## SERVICE BULLETIN NO. 398

TITLE NOISE FILTER INSTAL. - INTERIM FOR  
SYSTEM IV SHIPSPURPOSE REDUCE INVERTER NOISE AND AUTOPILOT  
NOISE AFFECTING SYSTEM IV

APPLICATION 370, 374, 376, 344

REF: R-32

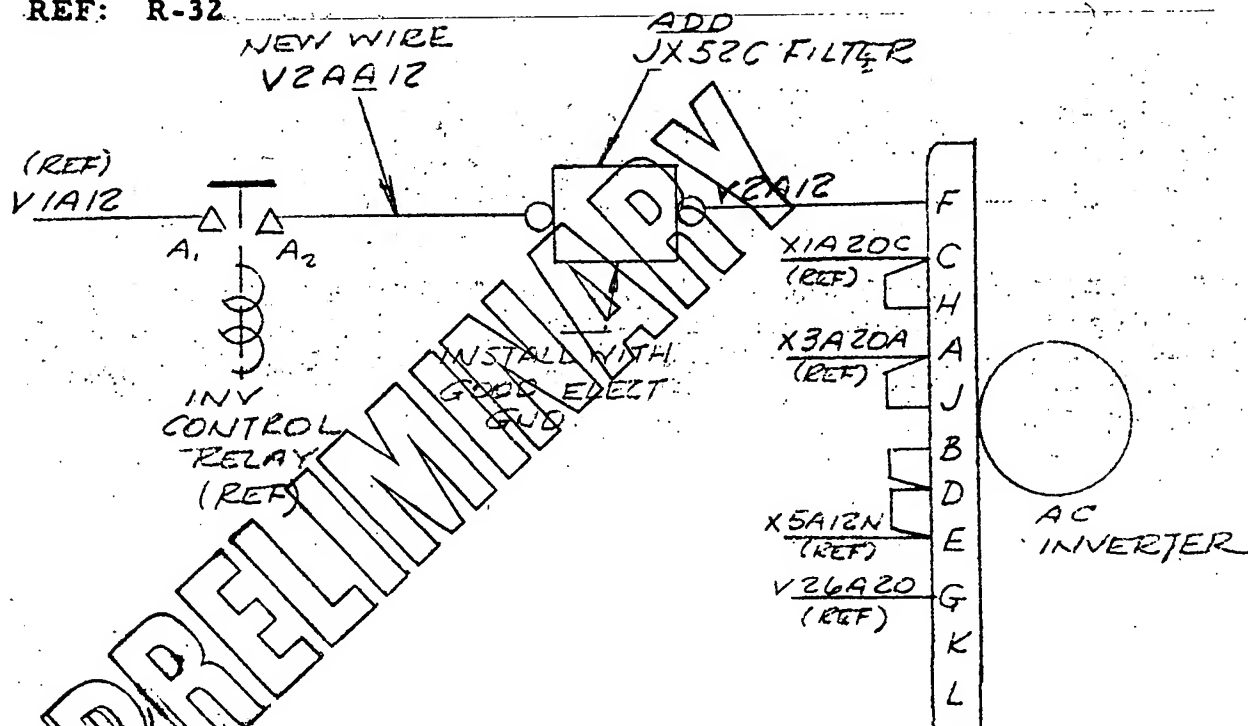
IN ORDER TO REDUCE INVERTER NOISE, INTRODUCED INTO THE 28V DC BUS SYSTEM AND WIRE BUNDLES OF THE EQUIPMENT BAY AREA, THE JX52C FILTER IS TO BE ADDED ON THE INVERTER SHELF. THE FILTER IS TO BE LOCATED WITHIN 6" OF THE INVERTER AND THE MOUNT IS TO BE A GOOD ELECTRICAL GROUND TO SHIP STRUCTURE.

THE ~~Y2A~~2C FILTER IS TO BE ADDED IN THE Y2A12 WIRE FROM INVERTER TO INVERTER CONTROL RELAY. IT IS TO BE LOCATED WITHIN 6" OF INVERTER. THE V2AA12 WIRE IS ENCLOSED WITH SERVICE BULLETIN TO PROVIDE NEEDED WIRE LENGTH.

REF: R-55

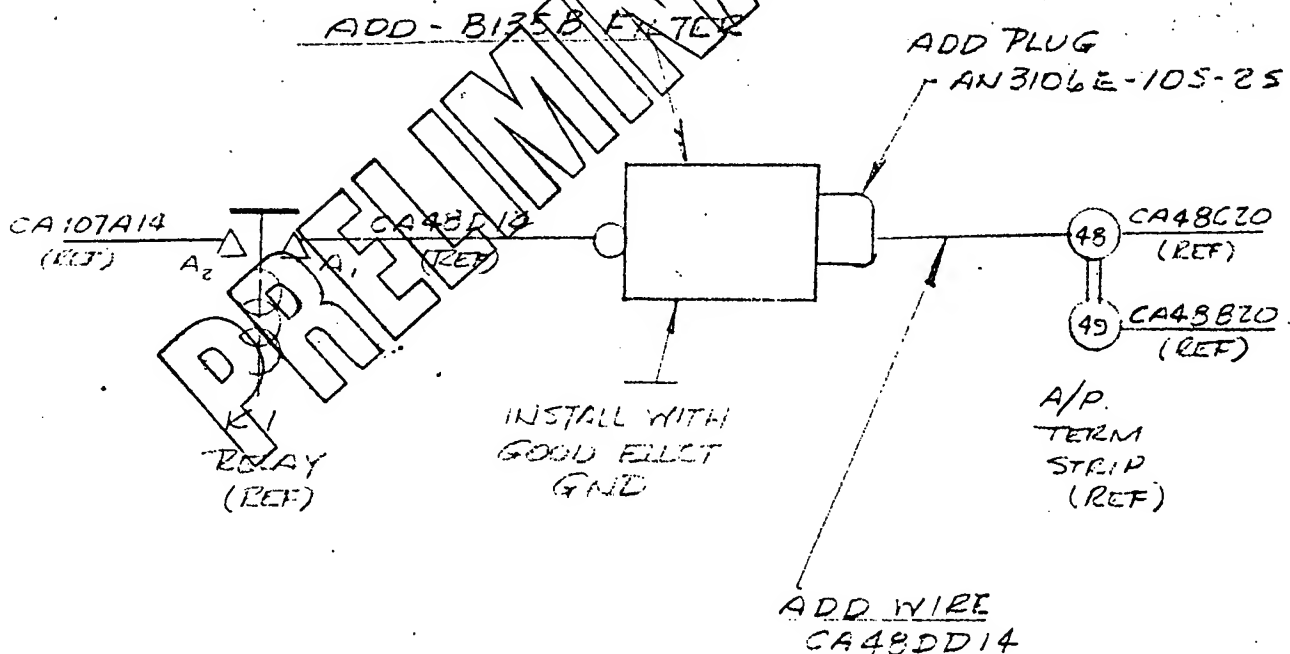
IN ORDER TO REDUCE TRANSIENT SPIKES OF 15 TO 20 VOLTS AMPLITUDE INDUCED IN R. H. WIRE BUNDLE AND NOISE TERMINAL STRIP AREA THE FOLLOWING FILTERS ARE TO BE ADDED.

- A. INSTALL B-135-B FILTER IN DC POWER CIRCUIT TO GYRO CONTROL AMPLIFIER. FILTER TO BE LOCATED ON NOSE RACK JUST BELOW PANEL SUPPORTING YAW DIRECTIONAL GYRO.

THE WIRING CHANGE IS AS FOLLOWS:
